UNLESS OTHERWISE SPECIFIED: DIMENSIONS ARE IN MILLIMETERS SURFACE FINISH: TOLERANCES: LINEAR: ANGULAR:					FINISH: HRC:		DEBUR AND BREAK SHARP EDGES		DO NOT SCALE DRAWING		REVISION					
											SUBEC AB					
PROJECT NAME:										TITLE: Wire Str. S80-Q-5 Single SD type						
PROJECT NO:																
	NAME		SIGNATURE		DATE											
DRAWN					2017-07-31											
MATERIAL:						ARTICLE NO: 1804A				DWG NO. 3-400420-00				A4		
Q.A								WEIGHT: g		SCALE:1:5			SHEET 1 OF 1		1804A

UNLESS OTHERWISE SPECIFIED: DIMENSIONS ARE IN MILLIMETERS SURFACE FINISH: TOLERANCES: LINEAR: ANGULAR:				FINISH: Black Oxid.		DEBUR AND BREAK SHARP EDGES		DO NOT SCALE DRAWING		REVISION					
				SUBEC AB											
PROJECT NAME:						TITLE: Shaft for SD80 roller									
PROJECT NO:															
NAME		SIGNATURE		DATE											
DRAWN				2010-03-02											
MATERIAL:				ARTICLE NO:				DWG NO.							
St.hexagon SW41c				SD80P5				SD80P5				A4			
Q.A				WEIGHT: 0.43 kg				SCALE:1:2				SHEET 1 OF 1		SD80P5

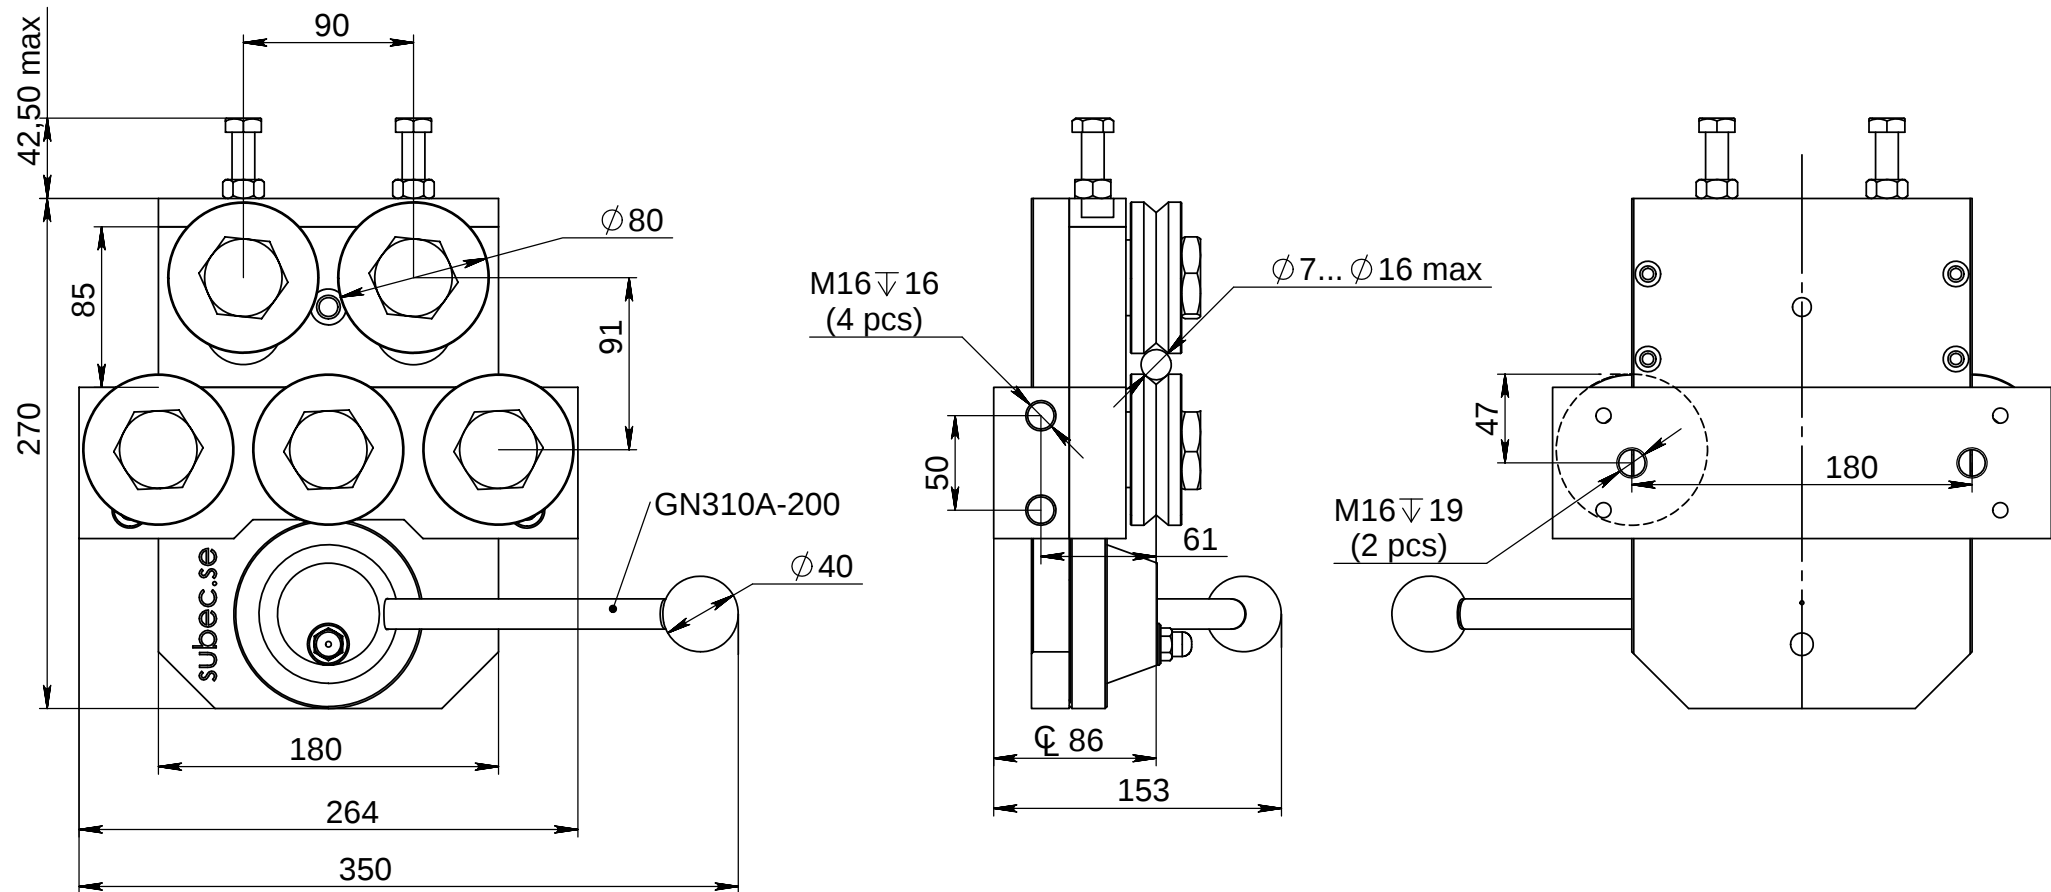
Revision A:

1. Changed design to be able to put product $\varnothing 16$;
2. Changed mounting holes to M16
3. Changed center height to CL86mm (changed thickness of rear plate to 40mm)
